ADDENDUM #01

Renovations & Addition

James Blackstone Memorial Library

S/P+A PROJECT NO. 16.108

DOOR, FRAME & WINDOW TYPES 4 A901

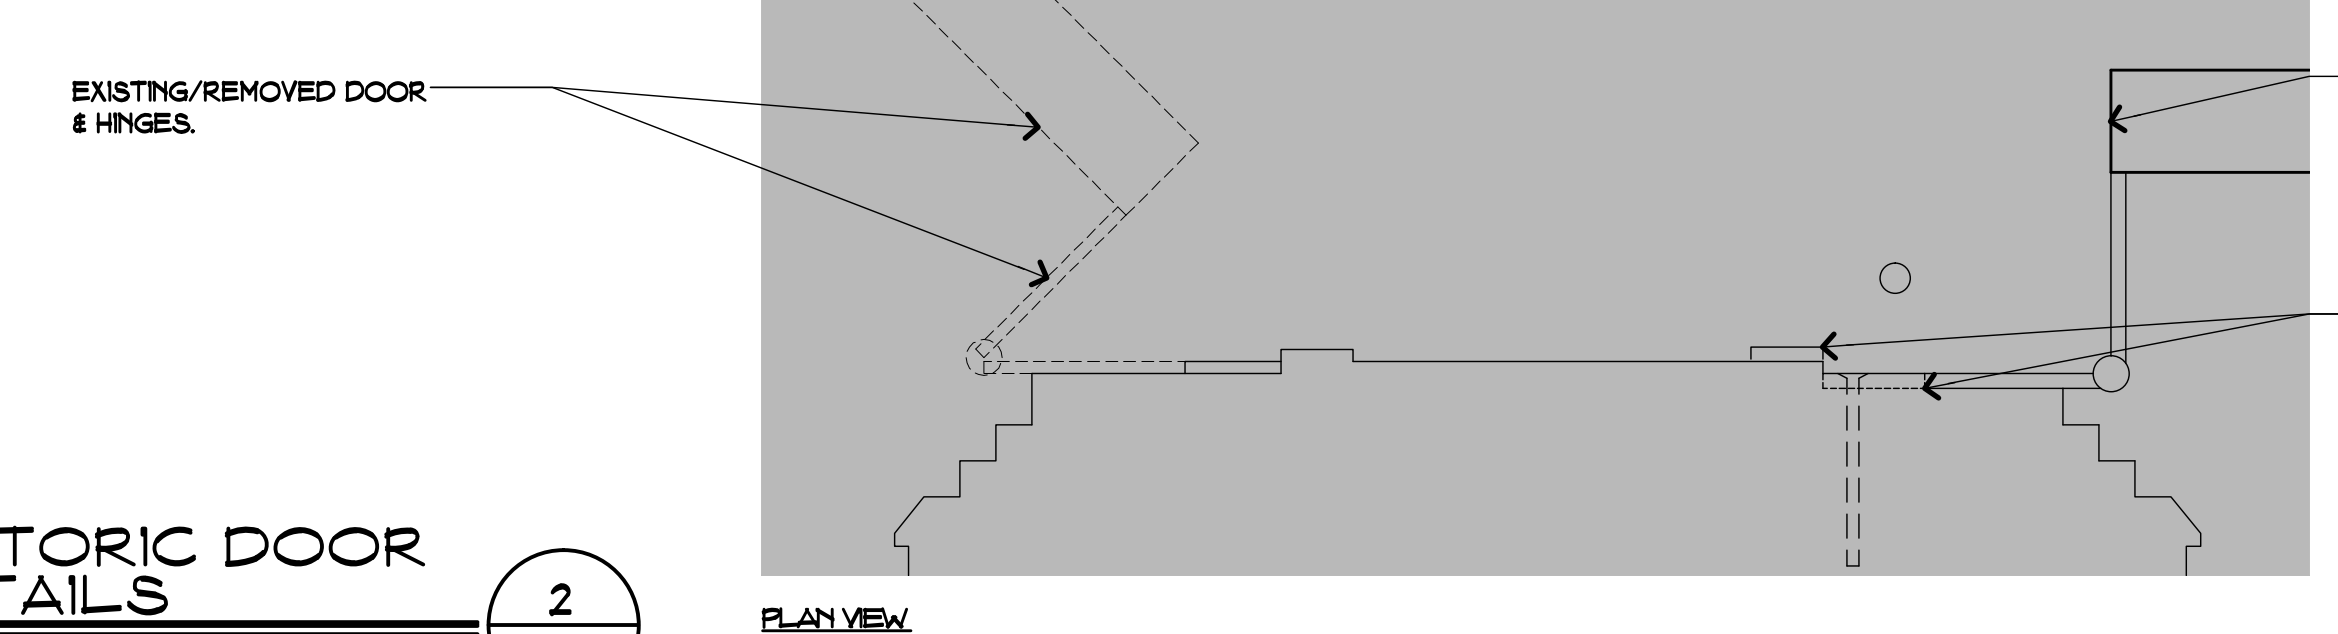
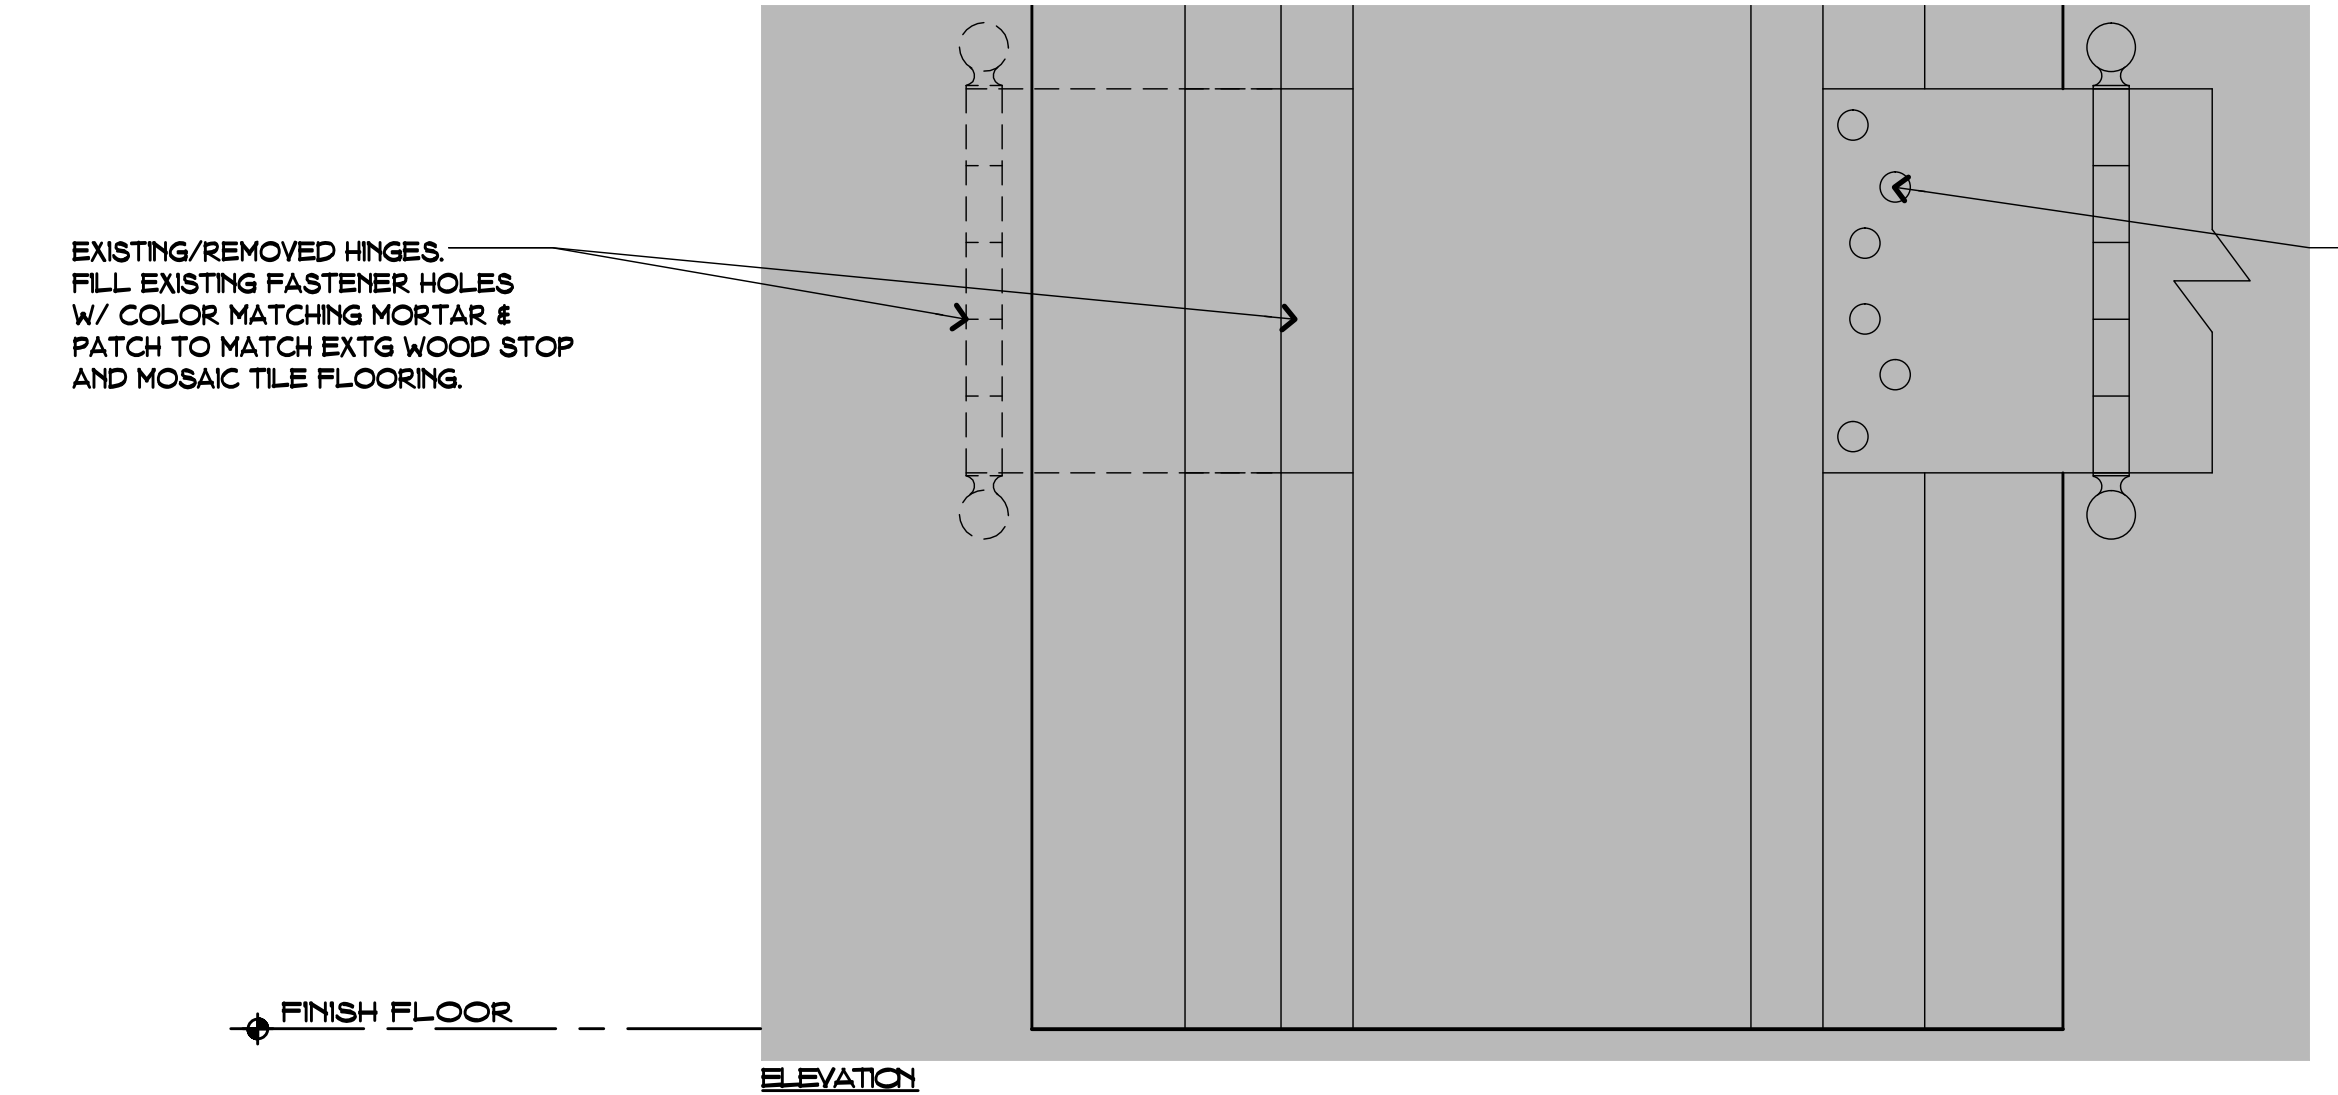
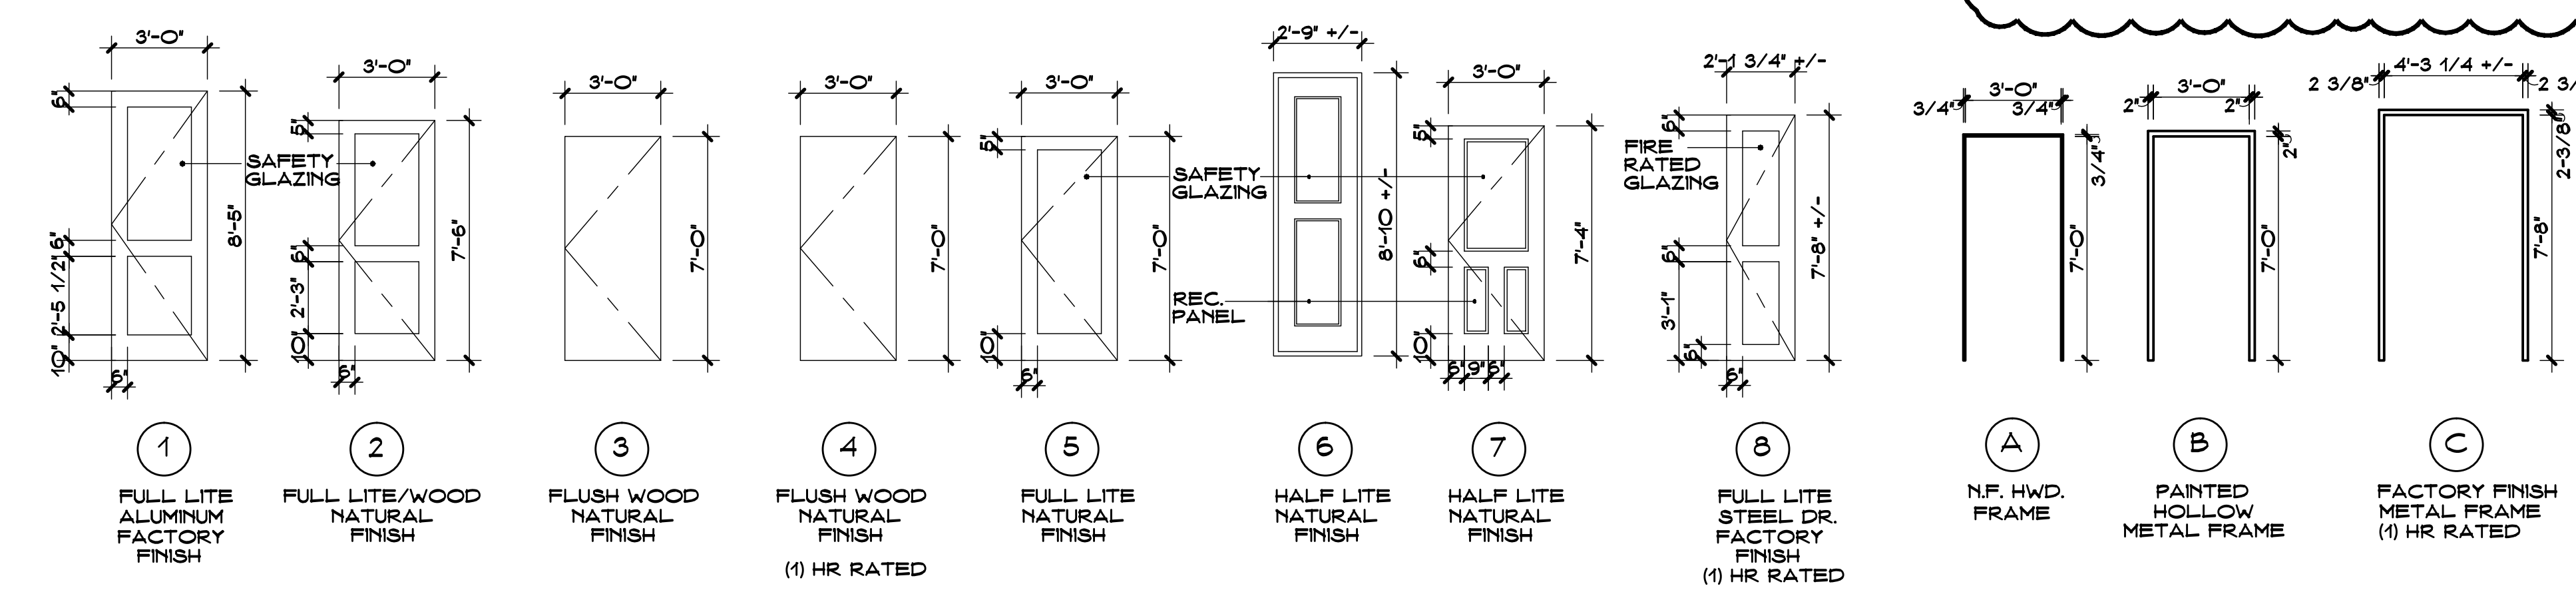
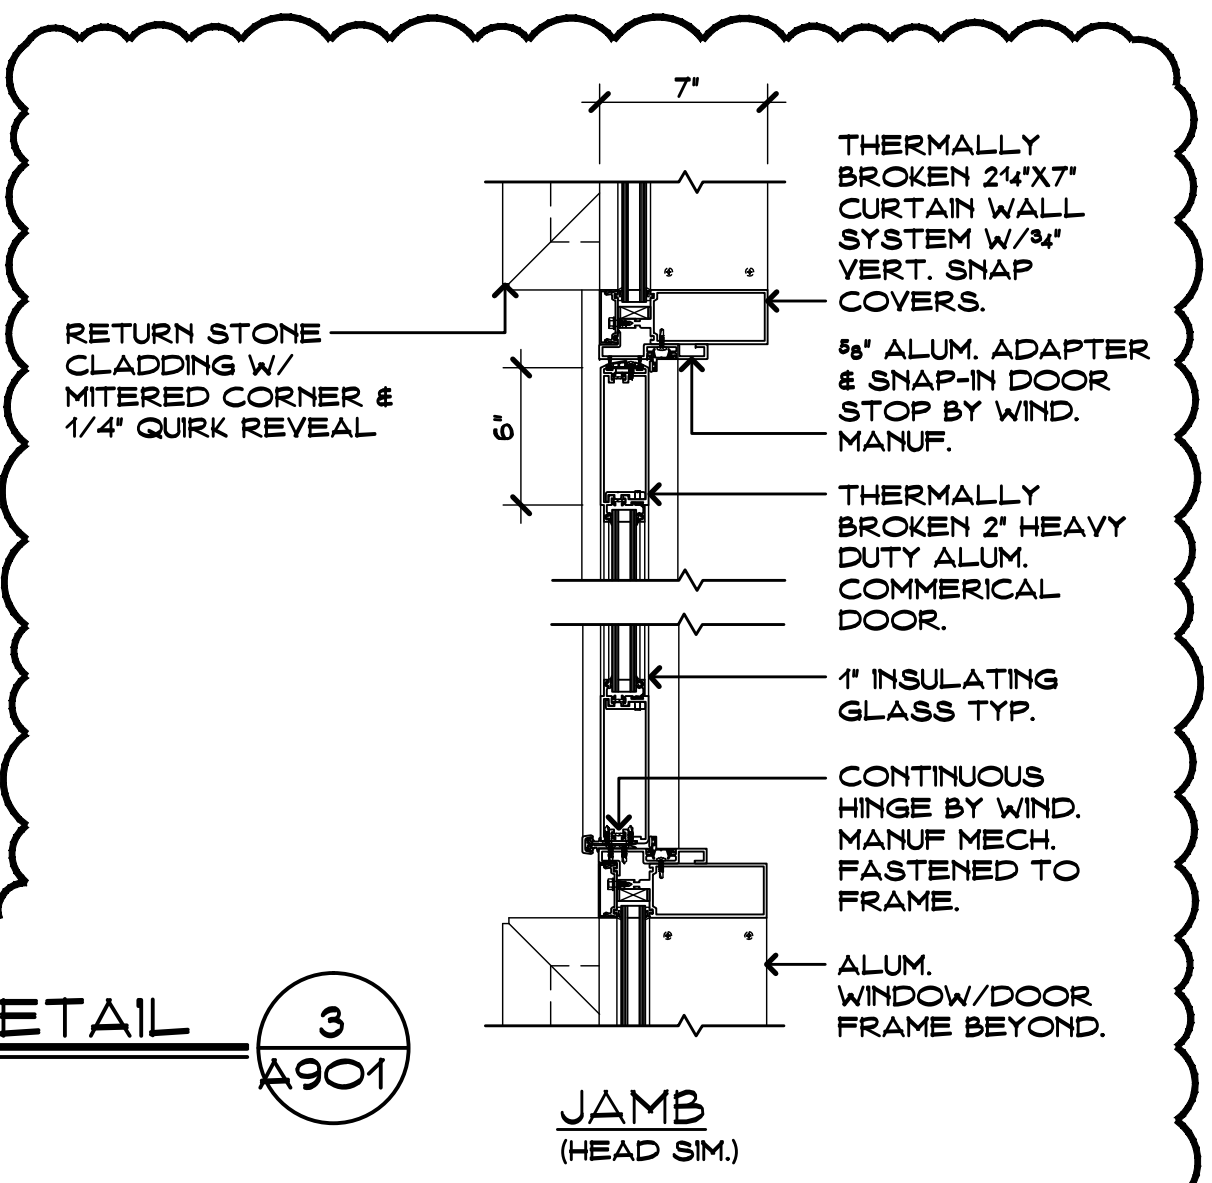
5. Revised Drawing A901
6. **All bidders** should incorporate the attached Bid RFI questions with answers, RFIs without response are pending.
7. PreBid Walk Through Agenda

Item No.	Discipline	Item / Description	Ball in Court	Response Comments
1	HM Doors and Frames	What Bid Package owns Sections 08 12 13 and 08 41 23 Fire Rated Systems	Downes	Furnished by Bid Package 8.1 Doors Frames and Hardware, installed by Bid Package 9.1 Drywall and Plaster
2	Glass/Glazing	A901 Window Types W5 & W6 are interior frames. Please advise frame and glass type	S+P	5/4" hardwood frame sim to detail 3/A900 with GL-2 glazing
3	Glass/Glazing	Please advise the extent of the mock-up	S+P	24" square mockup showing all typical connections and overall finished appearance
4	Metals/Glass/Glazing	Please advise if the Enduroshield glass coating shown on 088000 2.4 (D) is required. It is not mentioned in the GL-10 make up.	S+P	Provide coating to GL-5, exterior guardrail glazing
5	Doors/Fms/Hdwr / Glass/Glazing	Please confirm aluminum door hardware is done by others	Downes	Aluminum door hardware is furnish and installed by package 8.2 Glass & Glazing. Locking cylinders as scheduled are furnished by package 8.1.
